Stannah Lifts Safety Bulletin - Update

Issue No: M31(a)

LIFT TYPE: - Stannah Hydraulic Passenger Lifts with 2:1 Roping

Component Failure

Fig 1

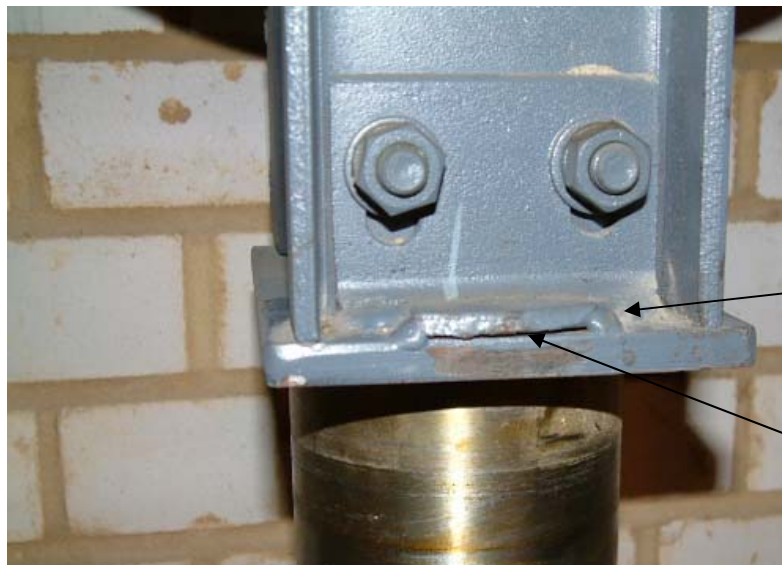
The welded bracket is fitted at the base of the tackle pulley assembly which supports the main suspension ropes and secures the top of the piston to the tackle pulley assembly (*see Fig 1 below*). It consists of a 10mm thick flat baseplate, to which are welded two notched angle brackets (approx 6mm thick).

Investigations indicate that this design of bracket was supplied and installed on lifts between 1986 and 1991. Evidence also suggests that the bracket which led to the incident was only partially welded and should have been fully welded as shown in Fig 2.

Replacement required

Welded in notched
corners of angle
bracket only

No weld along this
edge

No further related incidents have been reported. However, as a precautionary measure, it is recommended that all tackle pulley assemblies incorporating brackets identical to that shown in Fig 1 above are replaced with a different design available from Stannah Lifts Ltd.

It is strongly recommended that no full load rupture valve tests be undertaken (as required on LG1 test) on any brackets found to be to Fig 1 above.

Any replacement brackets for Fig 1 will be supplied free of charge and will be accompanied with a Sequence of Work for installation.

Fig 2
Replacement not required

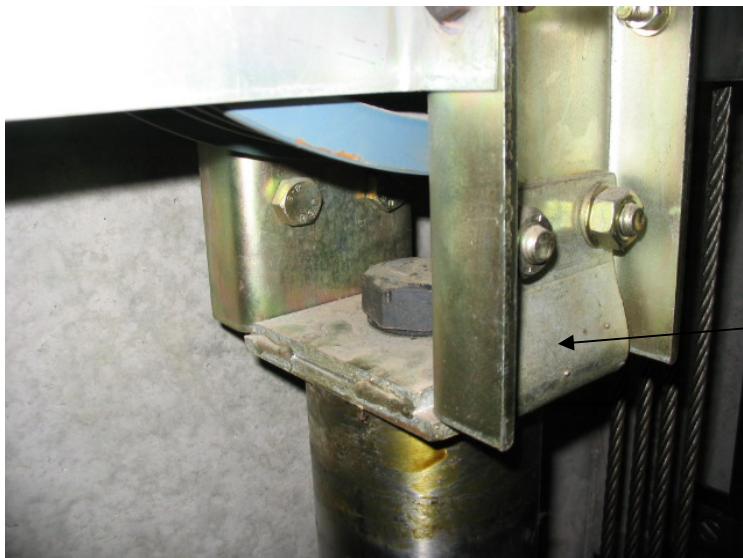
Bracket as Fig 1
but fully welded -
in notched corners
+ along edge of
bracket.

Welded brackets of the types shown in Figs 2, 3 and 4 below do not require replacement.
